PLANNING COMMISSION MEETING

4.A. PC Case 20-04 – Site Plan, Preliminary And Final Plat Review To Allow A Climate Controlled Storage Building At 1665 Oakdale Ave. – More Space LLC

To: **Planning Commission**
From: **Melissa Sonnek, City Planner**
Date: **May 19, 2020**

Site Plan, Preliminary, & Final Plat for 1665 Oakdale Ave – More Space LLC

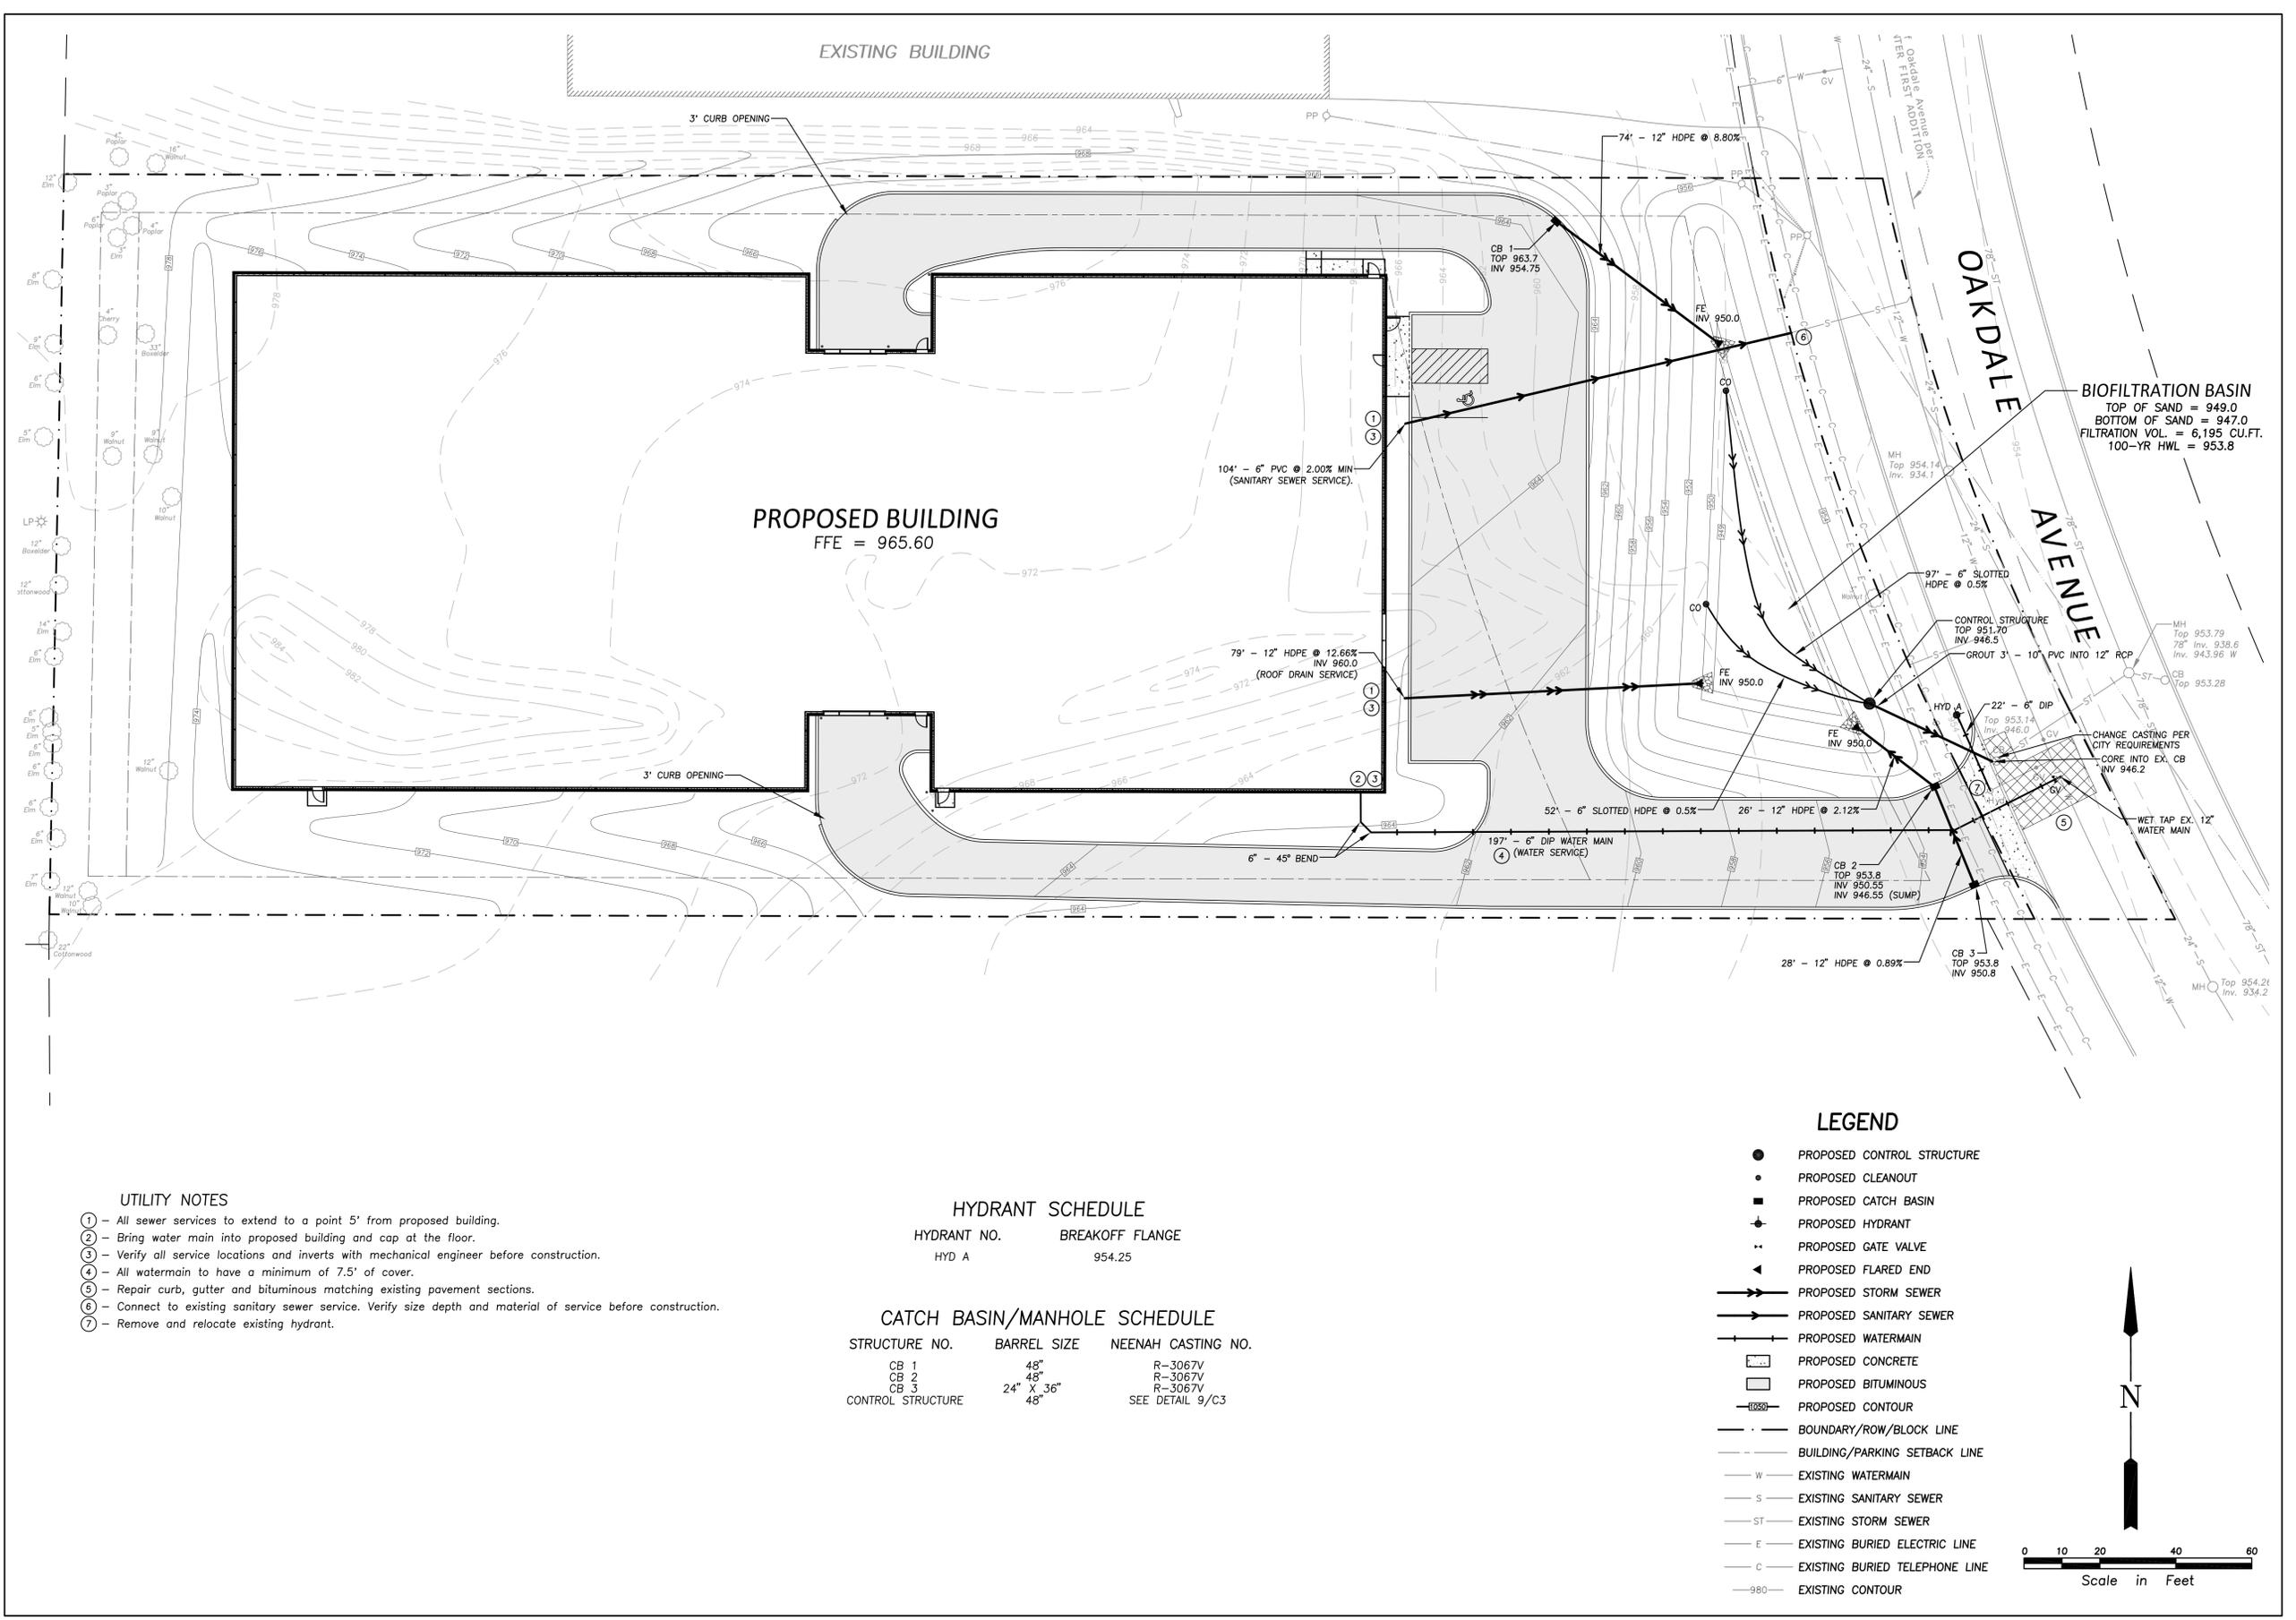
1. A callout should be added to the proposed pipe connecting into the catch basin along Oakdale Avenue to confirm its size, slope and material.
2. A sump should be added to CB 1 to provide pretreatment.
3. The elevation and location of the emergency overflow for the biofiltration basin should be added to the plan.
4. The corners of the bottom contours in the biofiltration basin should be smoothed out to make them constructible.
5. It is recommended additional storm sewer be added to pick up the runoff from the swales and route it to the biofiltration basin to reduce the amount of runoff running in the gutters.

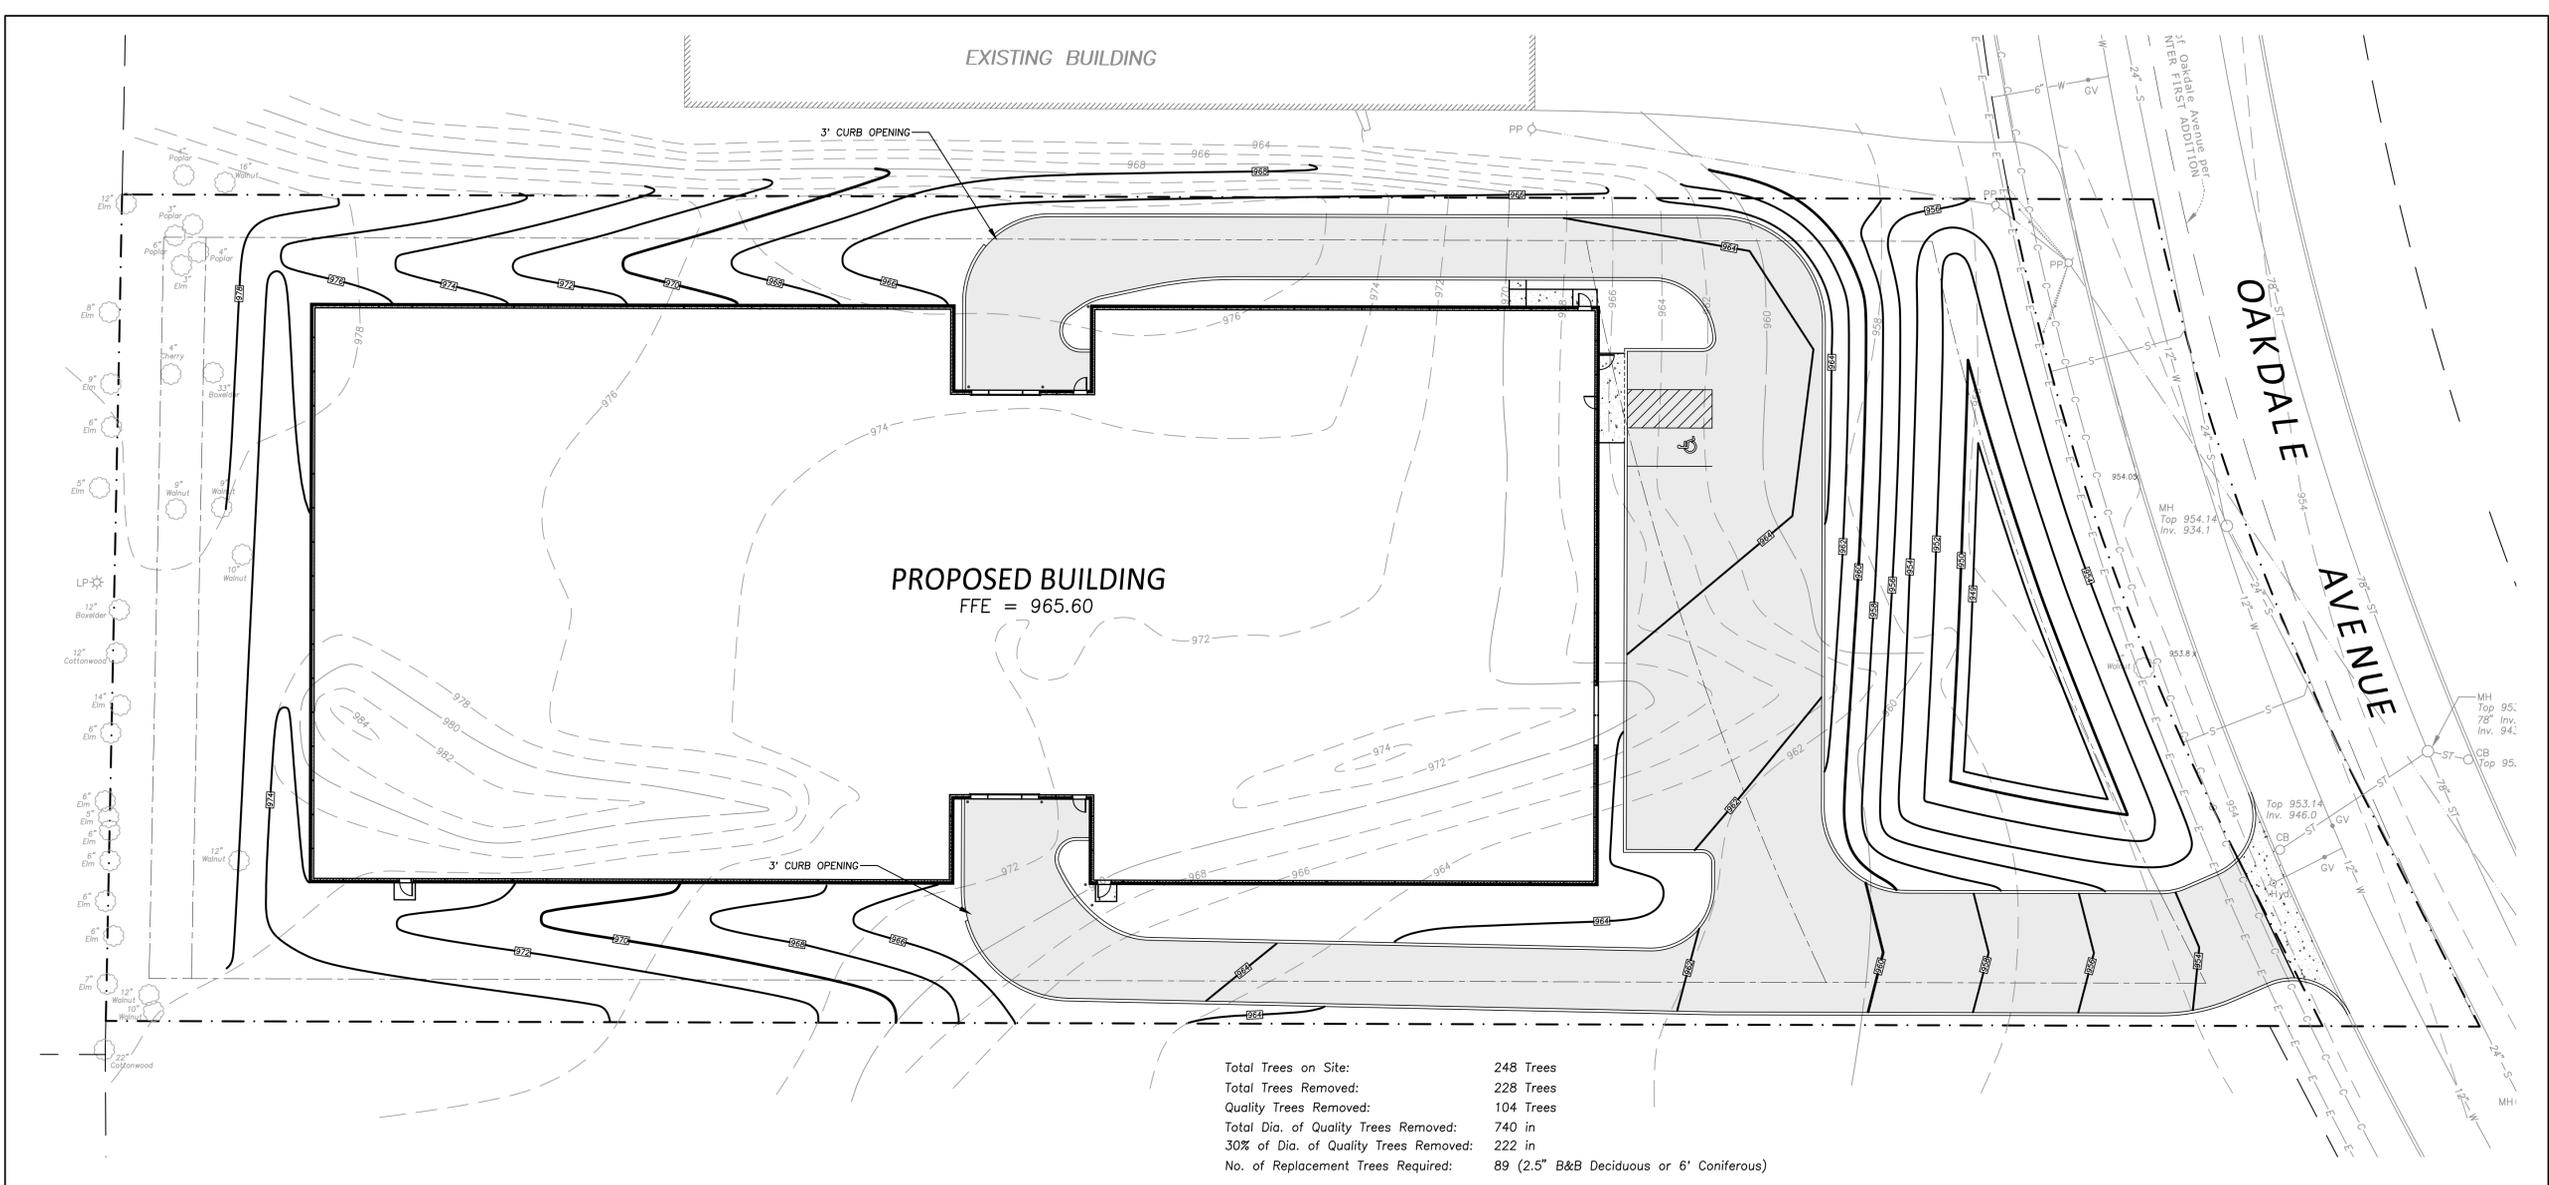
The submitted plans detail the removal of 104 quality trees (740 caliper inches). The zoning ordinance requires that whenever the removal of quality trees occurs, a minimum of 30 percent must be replaced. For the proposed removal, the required caliper inches to be replaced equates out to 222 caliper inches (or 89 trees that measure 2.5 caliper inches). The submitted plan numbers fall just short of the required minimum while proposing a total of 210 caliper inches (see landscape plan for specifics). As a result, City Staff is recommending as a condition of approval that the applicant either increase the number of trees or caliper inches of the proposed trees to meet the 222 caliper inches needed to meet the minimum.

Total Trees on Site: 248 Trees
Total Trees Removed: 228 Trees
Quality Trees Removed: 104 Trees
Total Dia. of Quality Trees Removed: 740 in
30% of Dia. of Quality Trees Removed: 222 in
No. of Replacement Trees Required: 89 (2.5" B&B Deciduous or 6" Coniferous)

4. The applicant revise plans to either increase the number of trees or increase the caliper inches of the proposed trees to meet the 222 caliper inches minimum requirement,

More Space - West St. Paul
 Oakdale Avenue
 West St. Paul, MN
 Landscape Plan

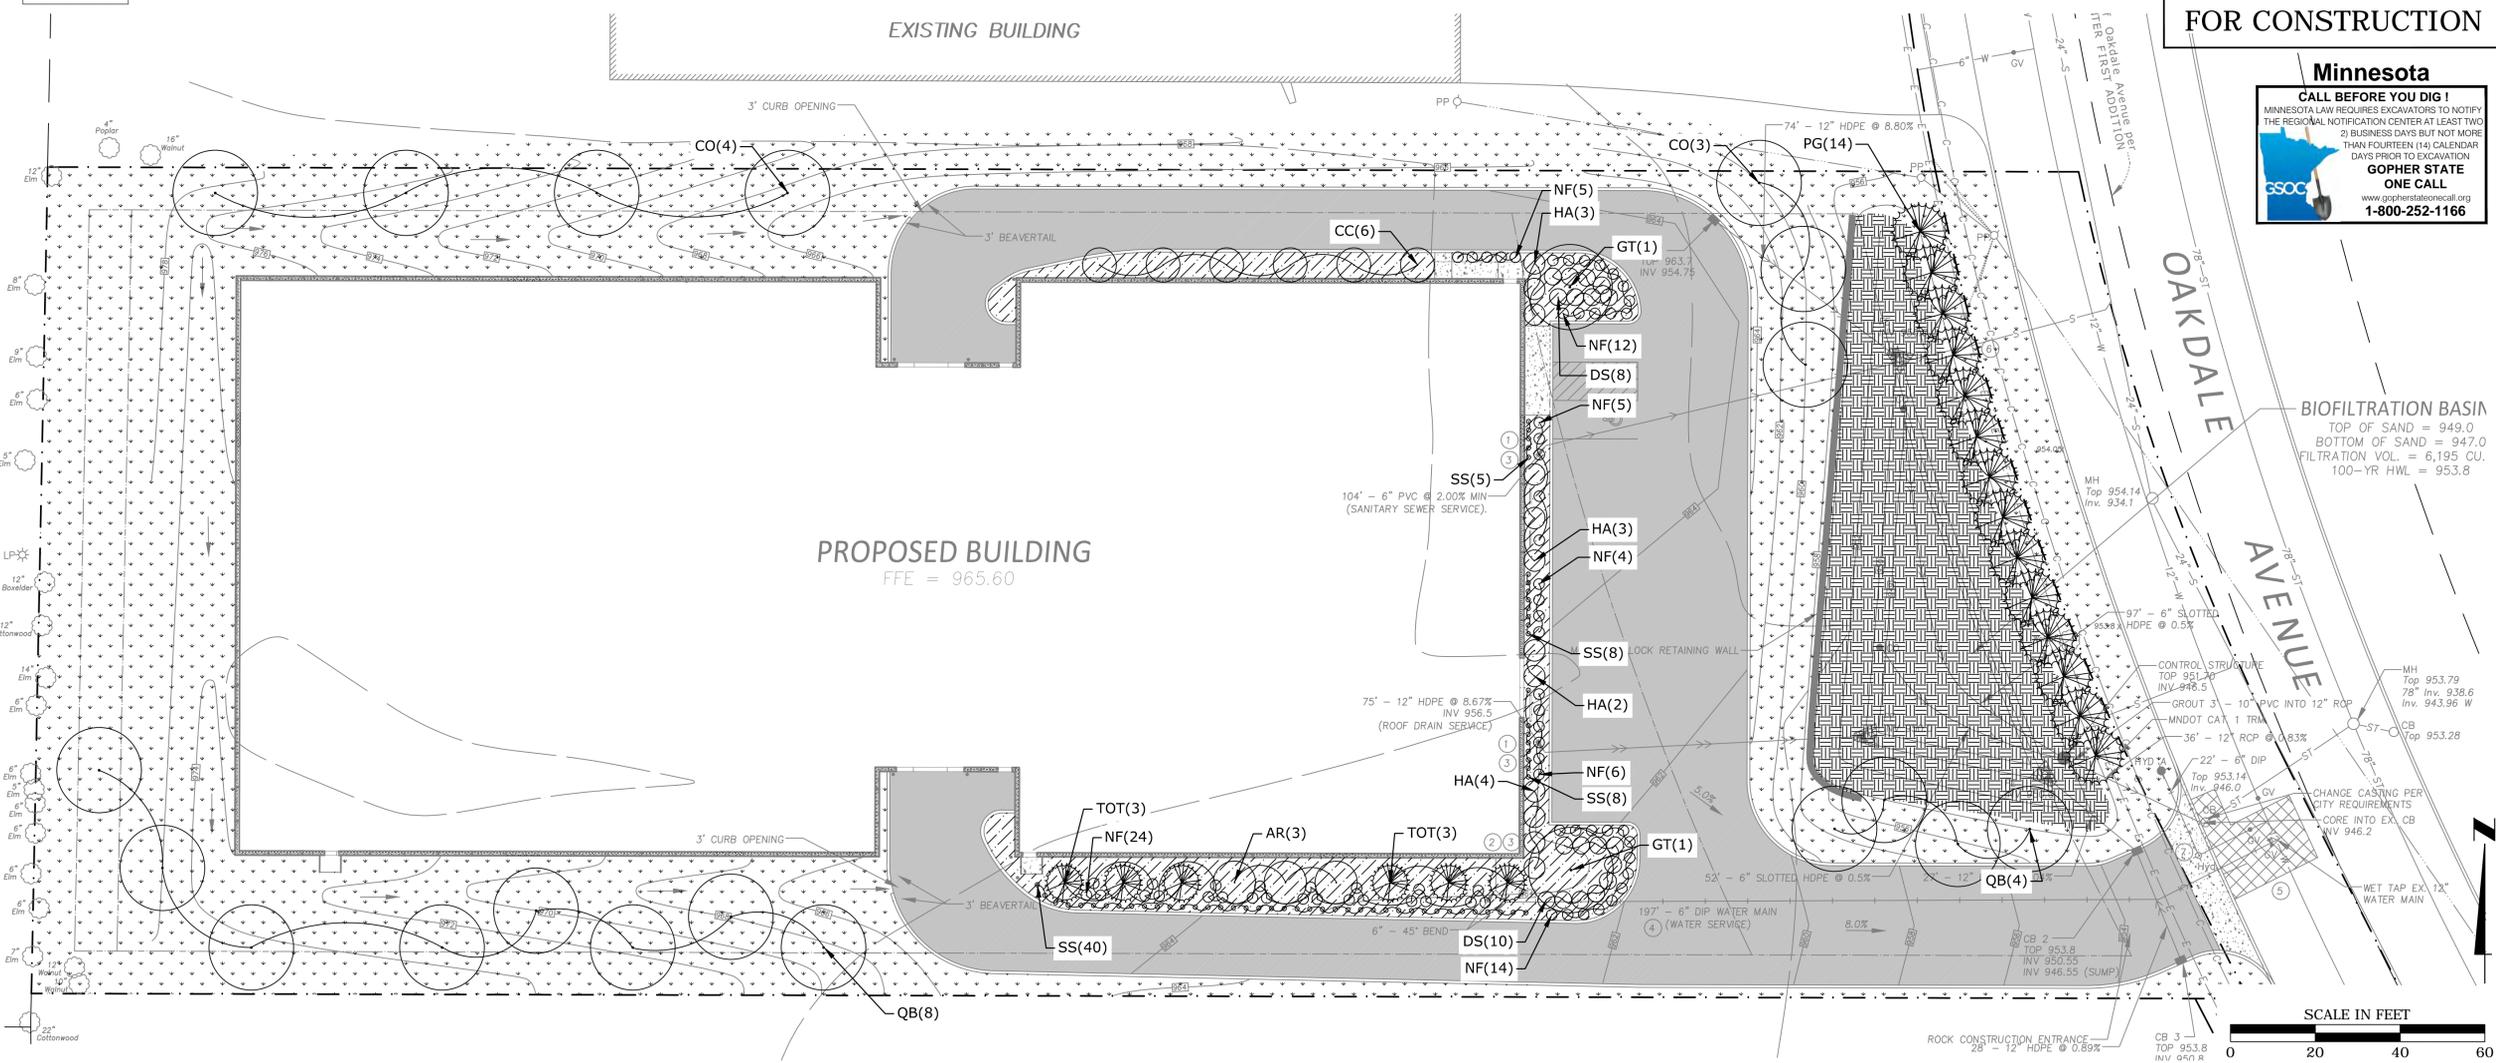
In addition, for development/redevelopment in commercial and industrial districts, the code requires one tree per 20 lineal ft. of property line, which for this property (1,398 lineal ft.) equates out to 70 trees. As shown in the attached plans, the applicant is proposing 50 deciduous trees, totaling to 210 caliper inches, as well as 30 shrubs, 70 perennials, and 61 ornamental grasses. Staff is comfortable with the lower number of trees since the proposed size of the trees is larger. Specifically the 14 evergreens located in the front yard that are expected to measure 30ft. in height.

As mentioned previously, the applicant is proposing several substantial evergreens to screen the large building from the park across the street. City Staff is satisfied with this proposal.

Lighting and Signage

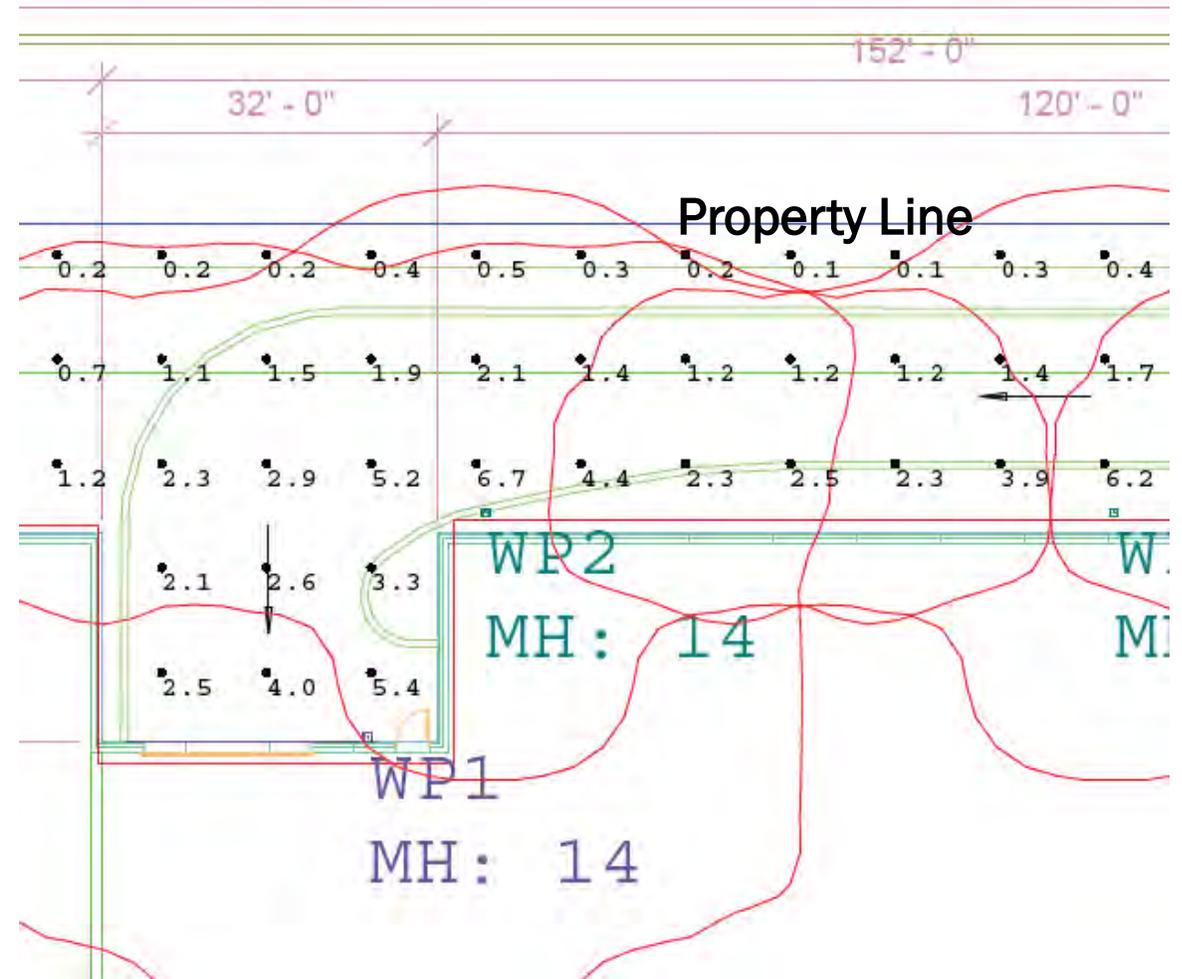
- The submitted lighting plans do show a small amount of light at the property line
 - City Staff is recommending the lighting plan be revised so lighting levels do not exceed zero foot candles at property lines

- The submitted plans do not include detail on signage for the property
 - City Staff is recommending that all signage comply with section 153 of the zoning ordinance
